The Applicant proposes to construct a 4,846 square foot (s.f.) building with three (3) tenant spaces and a drive-through on the westerly 2,200 s.f. tenant space for a restaurant on a 0.93-acre property in the C-N zoning district. The proposed tenant intends for the drive-through to be more of a pick-up location where customers would order ahead through a mobile app rather than ordering from a speaker or window; no speaker or menu board is proposed at this time.

PEAK AT SAWTOOTH VILLAGE  
FOR  
GRAND PEAK, LLC  
McMILLAN AND LINDER - MERIDIAN, ID

A. Proposed Site Plan (dated: 4/12/2022)

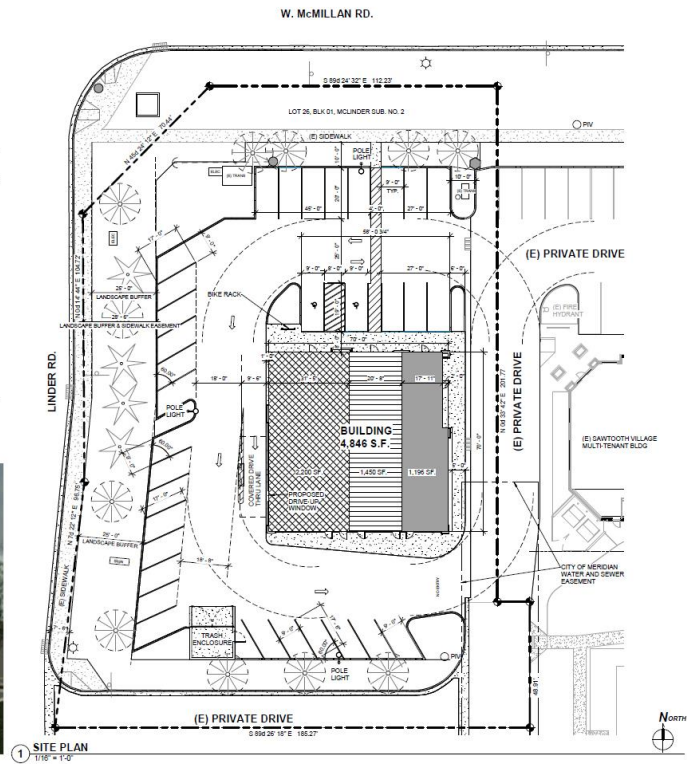
*The stacking lane will accommodate approximately five (5) vehicles, which the Applicant believes will be sufficient for their use/business model. Staff is concerned if the stacking lane backs up, the drive-aisle on the north side of the building may obstruct vehicles trying to enter or exit the parking spaces in that area. Also, while the proposed stacking lane may*

*accommodate the proposed user, it may not be able to accommodate future users that may be more intense without obstructing the drive aisle and parking on the north side of the building.*

*The stacking lane is a separate lane from the circulation lanes needed for access and parking on the west side of the building; however, if stacking backs up around the north side of the building it could obstruct parking in that area.*

**Based on the above analysis, Staff deems the proposed drive-through in general compliance with the specific use standards as required. If the Commission doesn't feel there is adequate stacking area to accommodate vehicles in the drive-through without obstructing the drive aisle needed for circulation and parking on the north side of the building, revisions may be required to the site design.**

**Certificate of Zoning Compliance application should reflect compliance with this standard – the proposed striping of the crosswalk is not allowed and should be revised to comply with this standard.**

**Easements:** There are several existing easements on this lot; see the subdivision plat for more information (i.e. McLinder Subdivision No. 2). **The site/landscape plan should be revised to depict all easements that exist on the.** Any encroachments within existing easements should be permitted through the easement holder.

2. The site plan and landscape plan submitted with the Certificate of Zoning Compliance application shall be revised as follows:
  - a. The stacking lane, menu and speaker location(s), and window location shall be depicted in accord with UDC [11-4-3-11B](#).

- c. The pathway from the perimeter sidewalk along W. McMillan Rd. to the main building entrance shall be distinguished from the vehicular driving surface through the use of pavers, colored or scored concrete, or bricks as set forth in UDC 11-3A-19B.4b.

- d. Depict all easements that exist on the subject lot per the recorded plat (McLinder Subdivision No. 2). Any encroachments within existing easements should be permitted through the easement holder.

- e. Depict signage at the southern driveway access on the east side of the site prohibiting entry in that location due to it being a one-way drive aisle and paint an arrow signifying one-way traffic on the drive-aisle.

## C. Building Elevations (dated: 4/12/22)

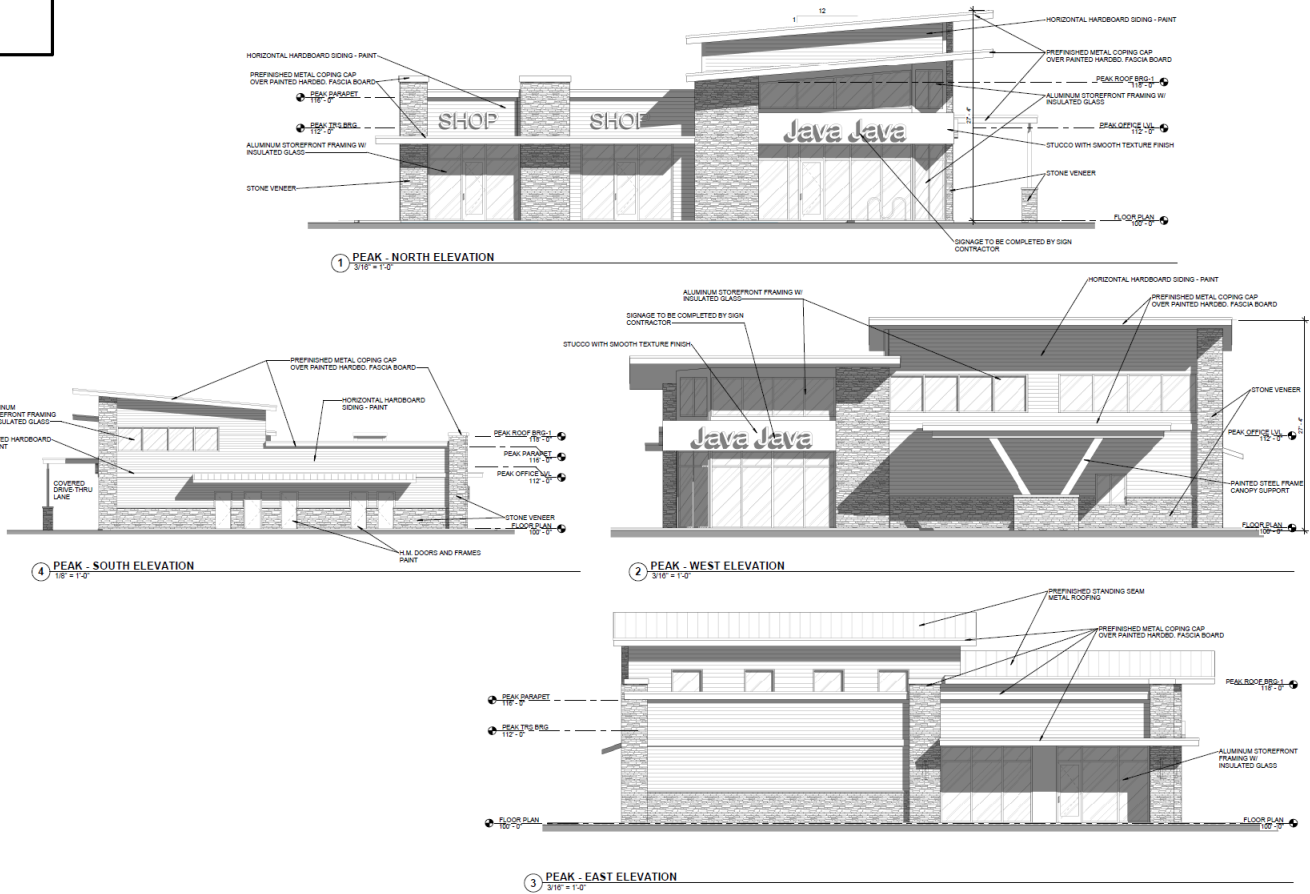
**Building Elevations:** Conceptual building elevations were submitted as shown in Section VII.C that incorporate a mix of materials consisting of horizontal hardboard siding, stone veneer and glazing. The final design shall be consistent with the design standards listed in the [Architectural Standards Manual](#).

7. A Certificate of Zoning Compliance and Design Review application shall be submitted and approved for the proposed use prior to submittal of a building permit application. The design of the site and structure shall comply with the standards listed in UDC [11-3A-19](#); the design standards listed in the *Architectural Standards Manual* and with the Development Agreement.
